# UNITED STATES PATENT AND TRADEMARK OFFICE

APPLICATION NO.	FILING DATE	FIRST NAMED INVENTOR	ATTORNEY DOCKET NO.	CONFIRMATION NO.
10/753,094	01/07/2004	Robert K. Kopras	035568-0122	2746

## Office Action Summary

Title: ATTACHMENT FOR POWER TOOL

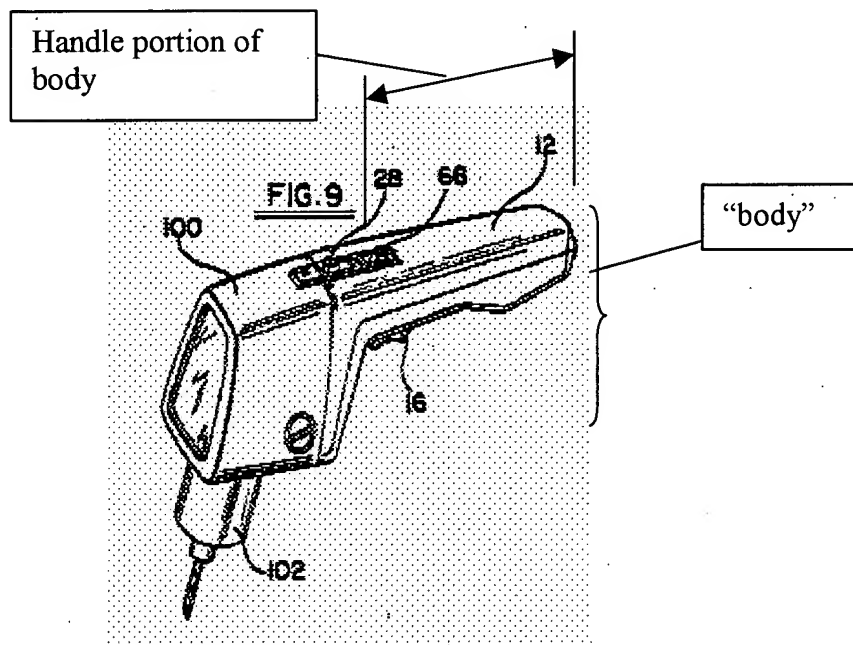
Figure 9 has at least a portion extending generally perpendicularly to a central longitudinal axis of the rotary cutting tool (see Figure 9).

Re the handle being of a “size sufficient to accommodate an entire palm of a power tool user”, as best understood, it is noted that the upper surface (as viewed in Figure 9) of the “handle” portion would appear to be large enough to support the entire palm of a user of the power tool (see Figure 9).

Re the “base” limitation of claim 1, as broadly claimed, note that the tool head 100 is a “base” coupled to the “body”, and is “selectively adjustable” between extended and retracted positions relative to the “body” (wherein the “extended” position of such is shown in Figure 4 and the “retracted” position in Figure 3, for example). Additionally, broadly speaking, the “base” 100 can be considered to “adjust” the depth of cut between there **being** a depth of cut

Re claim 2, also note that the “body” (the left portion of element 12 can be so considered, as viewed in Figure 2) is integral with the handle (see Figure 9 above), and includes members 52 and 54 for coupling the handle to the tool (see Figures 2-4, for example).

FIG. 3D

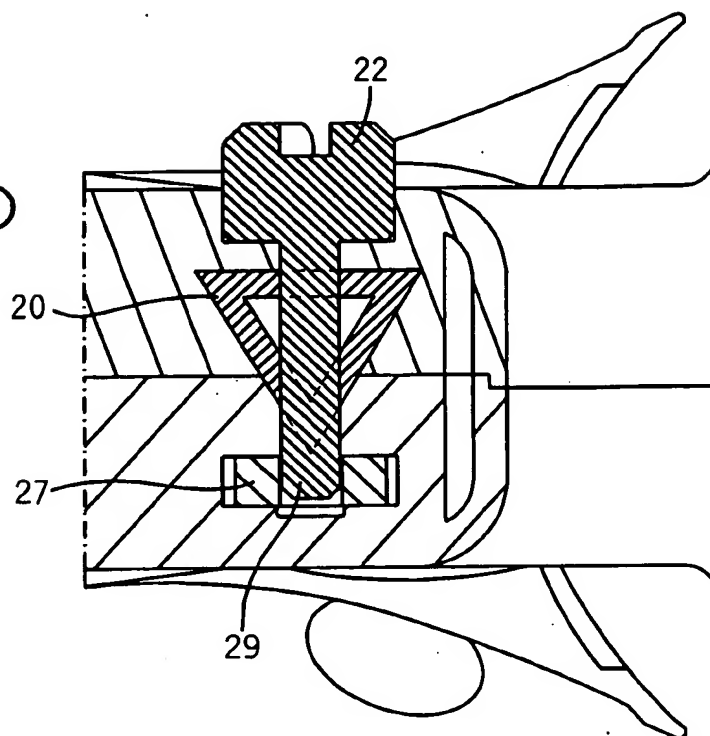
3. The amendment filed February 27, 2006 is objected to under 35 U.S.C. 132(a) because it introduces new matter into the disclosure. 35 U.S.C. 132(a) states that no amendment shall introduce new matter into the disclosure of the invention. The added material which is not supported by the original disclosure is as follows: The proposed Figures 3D through 3I are not approved because, even though the original specification does teach that the shaft can have a cross-sectional shape of a "triangle, a pentagon, a hexagon, a diamond, a rhombus, an octagon..." (at least paragraph 0051), the specification does not provide for the level of detail shown in the new Figures 3D through 3I. For example, the specification does not teach whether the triangle is a right triangle, an isosceles triangle, a scalene triangle, an equilateral triangle, etc., and specifically does not teach that the triangle is a triangle having the shape shown in Figure 3D, nor that the triangular cross section is configured or located as shown in Figure 3D such that it is intersected by the thumbscrew 22 at the locations of the triangle that are shown in Figure

3D. With regard to the other shapes claimed, similarly, the specification as originally filed does not teach any details of the polygonal shape beyond the “pentagon, hexagon, diamond, rhombus, or octagon” description, and thus doesn’t teach, with respect to the pentagon, hexagon, diamond, or octagon, whether the sides are of the same length or not, nor does the specification teach how these shapes are positioned or configured with respect to the device such that it is known where they are intersected by the thumbscrew 22. Furthermore, the specification does not appear to teach that the cross-section of each of these shaft shapes is a hollow cross section as is shown in new Figures 3D through 3I.

4. The drawings are objected to under 37 CFR 1.83(a). The drawings must show every feature of the invention specified in the claims. Therefore, the shaft having a cross-sectional shape that is selected from a “triangle, a pentagon, a hexagon, a diamond, a rhombus, and an octagon” of claim 8 must be shown or the feature(s) canceled from the claim(s). No new matter should be entered.

5. The amendment filed February 27, 2006 is objected to under 35 U.S.C. 132(a) because it introduces new matter into the disclosure. 35 U.S.C. 132(a) states that no amendment shall introduce new matter into the disclosure of the invention. The added material which is not supported by the original disclosure is as follows: the addition to paragraph 0051 that refers to the new figures 3D-3I, which, as described above, contain new matter; the new paragraphs 0019A through 0019F, which refer to the new figures 3D-3I, which, as described above, contain new matter.

Not  
Approved  
5/24/06  
GAC

Applicant is required to cancel the new matter in the reply to this Office Action.

FIG. 3F

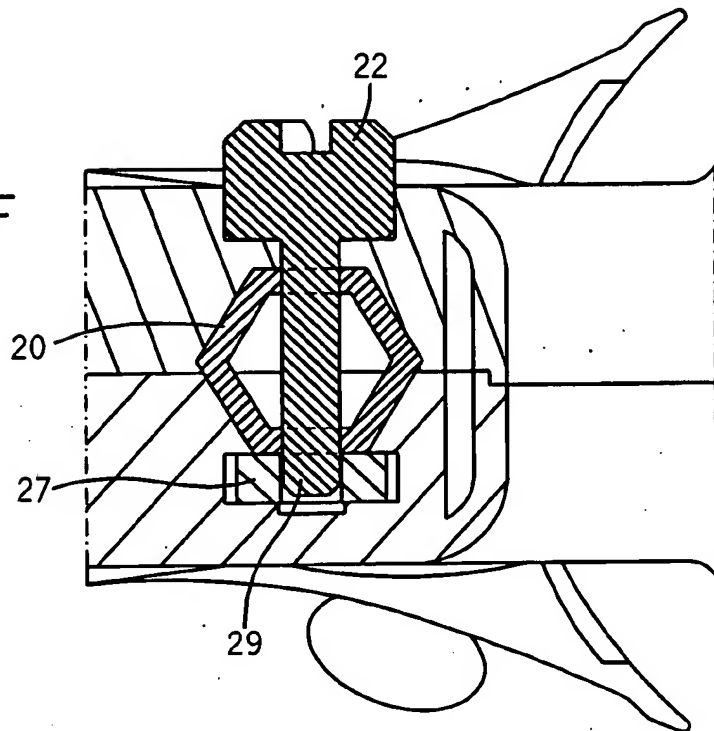
Not  
Approved  
ccc 5/24/06

FIG. 3H

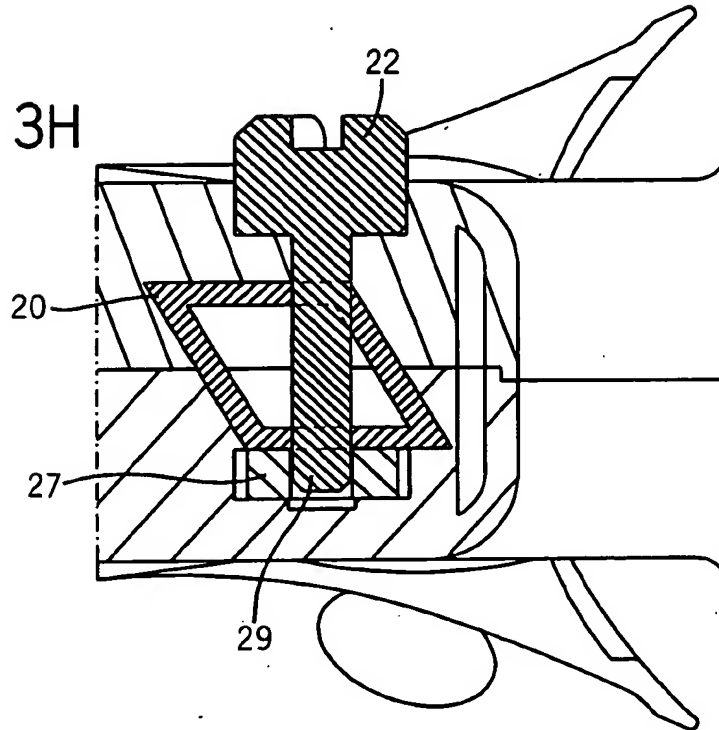
Not Approved  
5/29/06  
Gee
